re: **Geotechnical Design Summary Details**
Proposed Residential Development
5331 Fernbank Road – Ottawa, Ontario

date: November 18, 2025

file: PG5683-MEMO.02 Revision 4

SERVICES	
	PROJECT No.
	121011-00
	REV
	REV # 6
	DRAWING No.
	121011-001

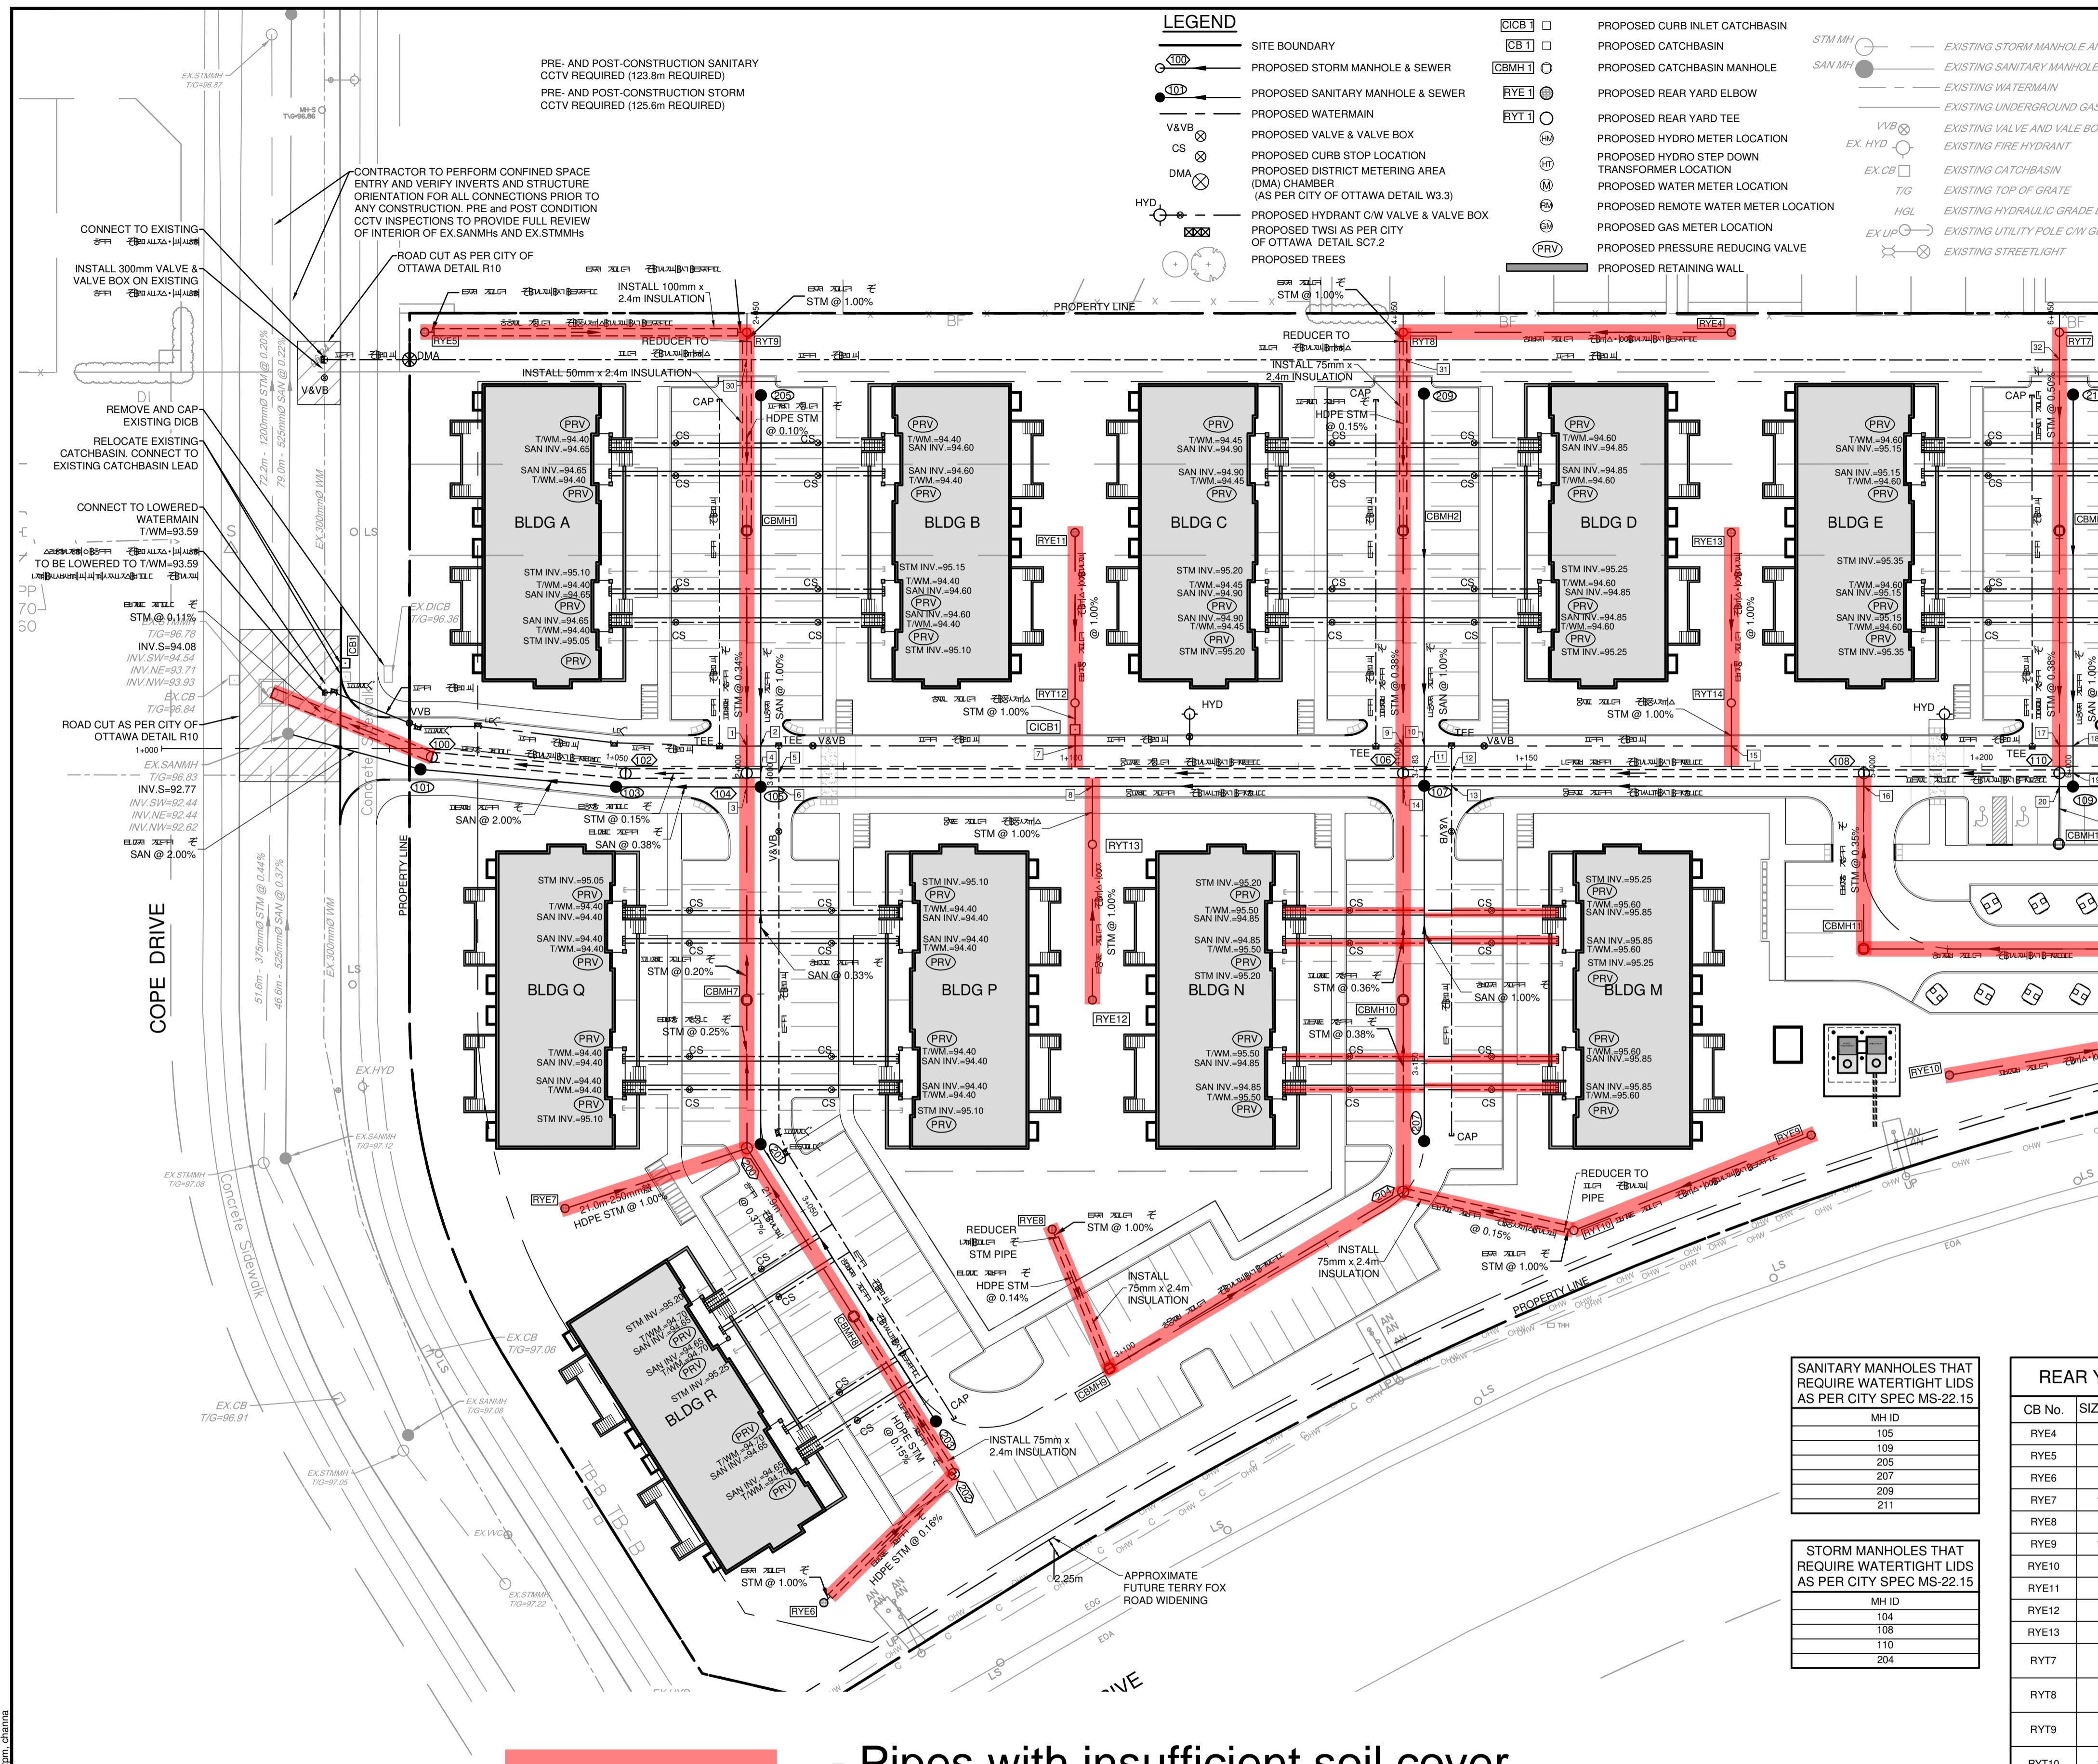
From our review of the above-noted site servicing plan, a number of servicing pipe sections are not provided with sufficient soil cover of 2.1 m for adequate frost protection (measured from the proposed ground surface to the pipe obvert). Reference should be made to the marked-up servicing plans which show the areas with insufficient soil cover, attached to the current report.

- Pipes with insufficient soil cover

For services with less than 2.1 m soil cover, a combination of soil cover and rigid insulation should be used, as detailed in Table 1 below.

Table 1 – Rigid Insulation Recommendations for Pipes with Reduced Soil Cover			
Thermal Condition	Soil Cover Provided (mm)	Insulation Dimensions	
		Thickness (mm)	Extension (mm)
Unheated	1800-2000	25	Extend 600 mm horizontally beyond edge of the pipe
	1500-1800	50	Extend 900 mm horizontally beyond edge of the pipe
	1200-1500	75	Extend 1200 mm horizontally beyond edge of the pipe

121011-GP2
#18539

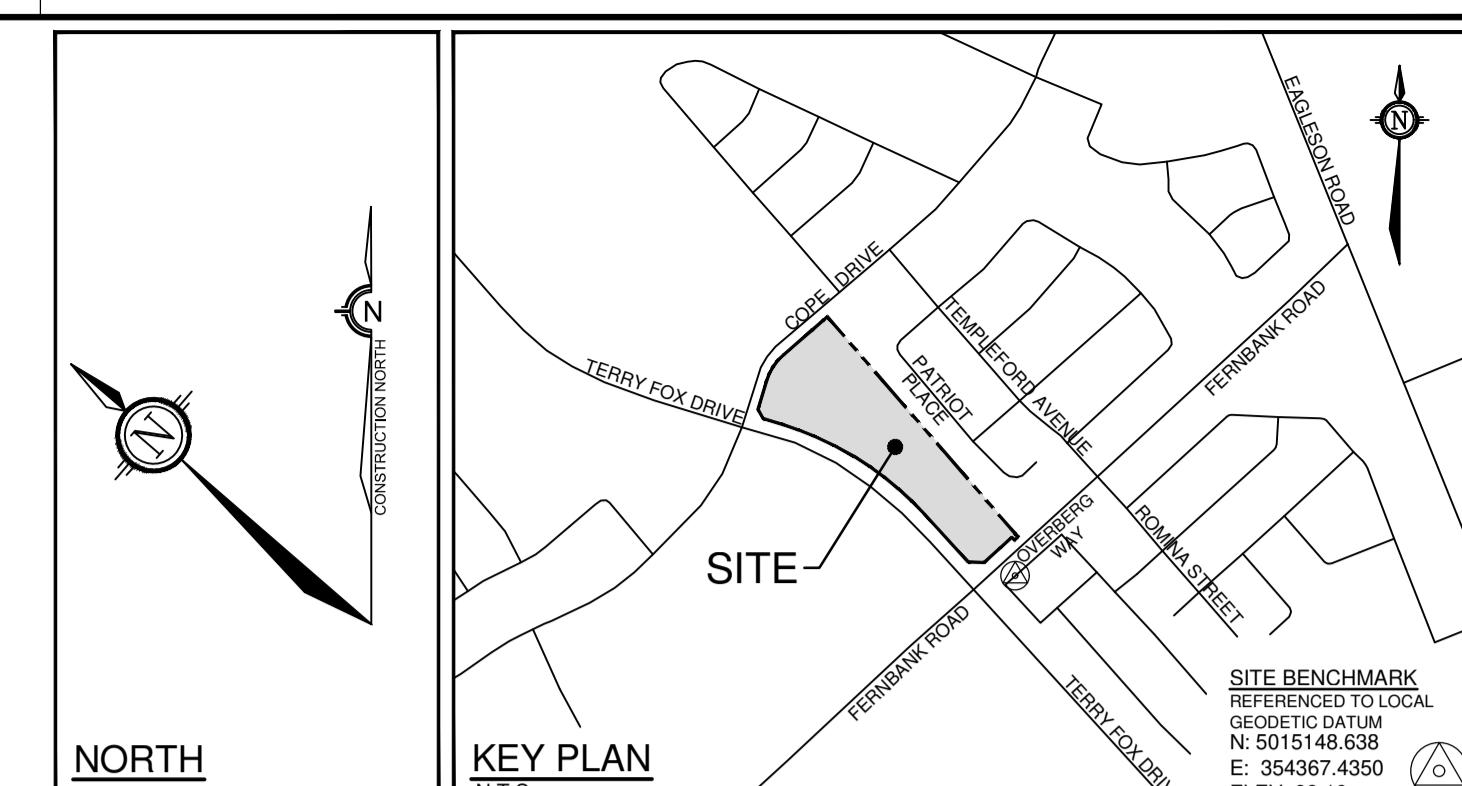
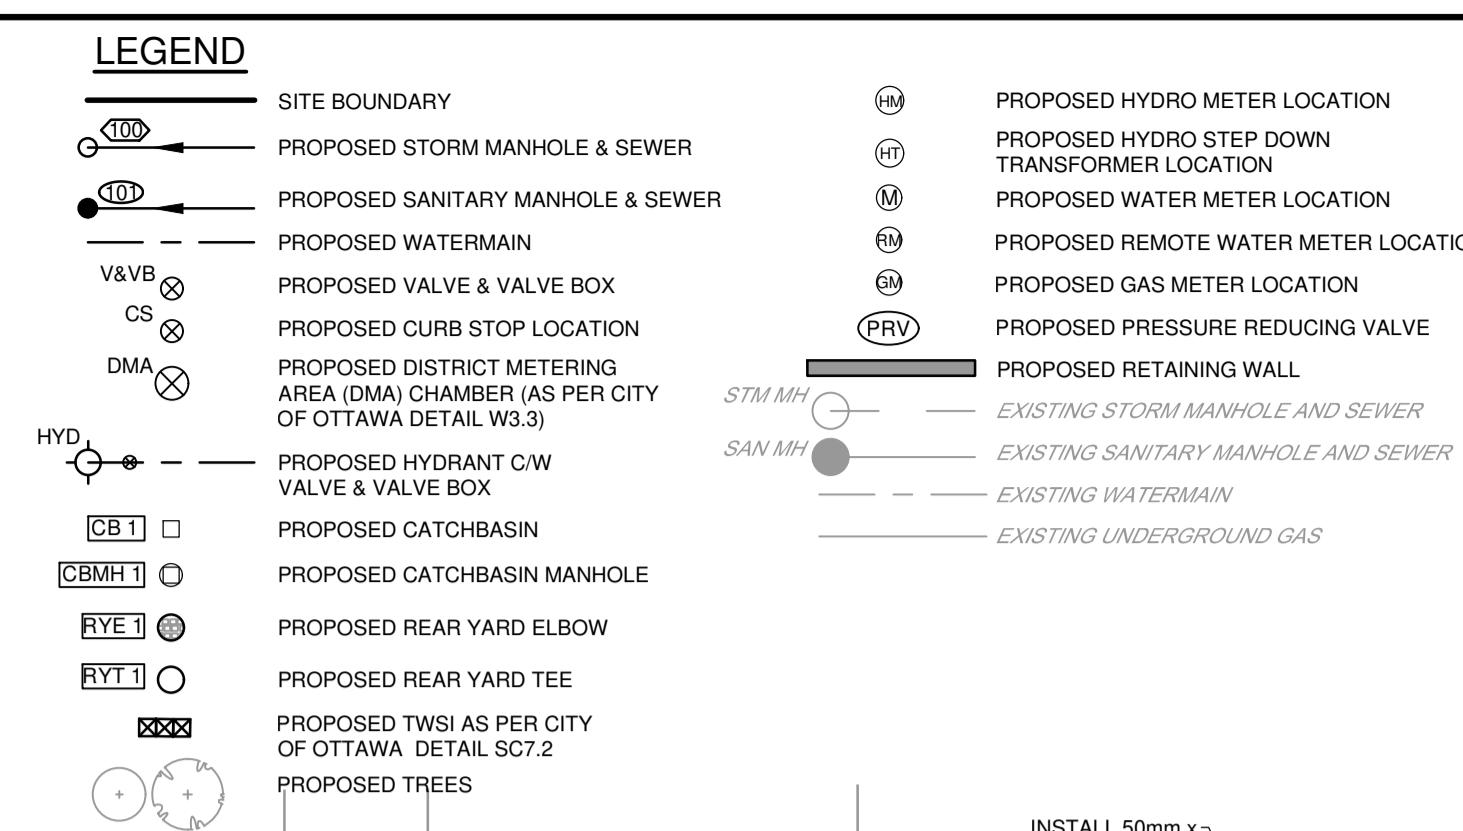
- Pipes with insufficient soil cover

Alternatively, instead of extending the rigid insulation 600 to 1200 mm beyond the edge of the pipe, the rigid insulation can be “boxed” around the pipe by transitioning from horizontal to vertical placement of the rigid insulation and extending to the invert pipe elevation, effectively forming a box of rigid insulation around the pipe. In this case, the rigid insulation should still be extended far enough to provide adequate spring-line and cover backfill material around the pipe.

DRAWING	
LANDSCAPE PLAN	
STAMP	SCALE AS SHOWN
START DATE JUNE, 2021	
PROJECT NO. 21-CLG-2163	
PROJECT NORTH	DRAWING NO.
 ASSOCIATION OF LANDSCAPE ARCHITECTS ONTARIO MEMBER	
PLOT SIZE ARCH-D	
L.1

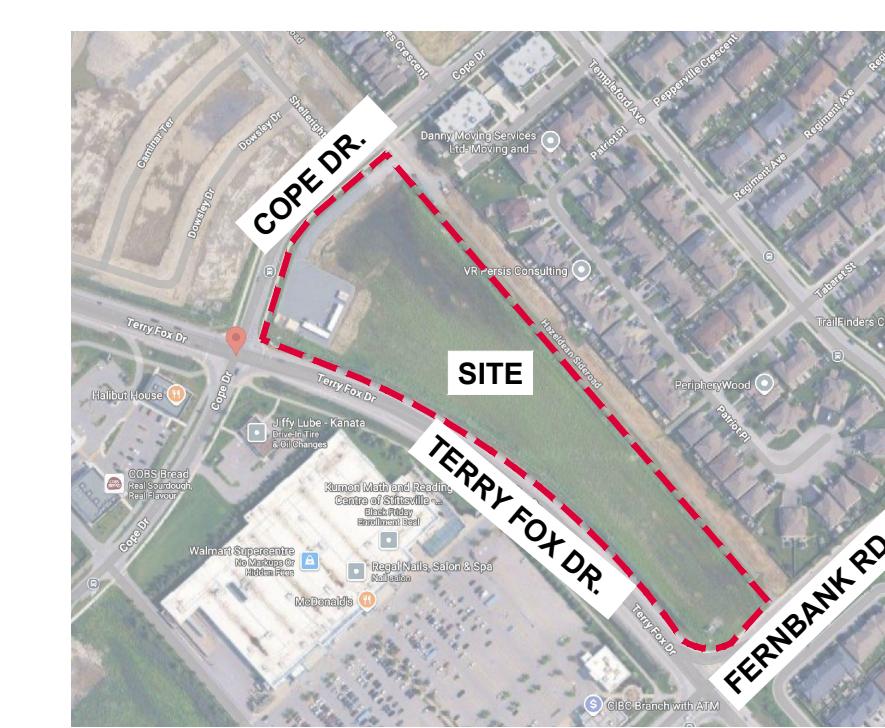
Based on the above-noted drawing, a minimum setback of 4.5 m from the nearest building foundation is provided for the majority of the proposed trees at the subject site. However, a small number of trees are not provided with the required 4.5 m setback. Reference should be made to the marked-up landscaping plans which show the trees with an insufficient setback, attached to the current memorandum.

- Indicates the minimum 4.5 m setback from building foundation is not provided.

Per discussion with JBLA, the proposed trees will consist of Japanese Lilac trees with a shallow, non-aggressive root system. Furthermore, it is understood that the remainder of the conditions noted in Subsection 3.1 of the current report will be incorporated into the design of the proposed development.

Accordingly, the proposed landscaping design is acceptable from a geotechnical perspective and is in conformance with Paterson's recommendations provided in the aforementioned geotechnical investigation report.
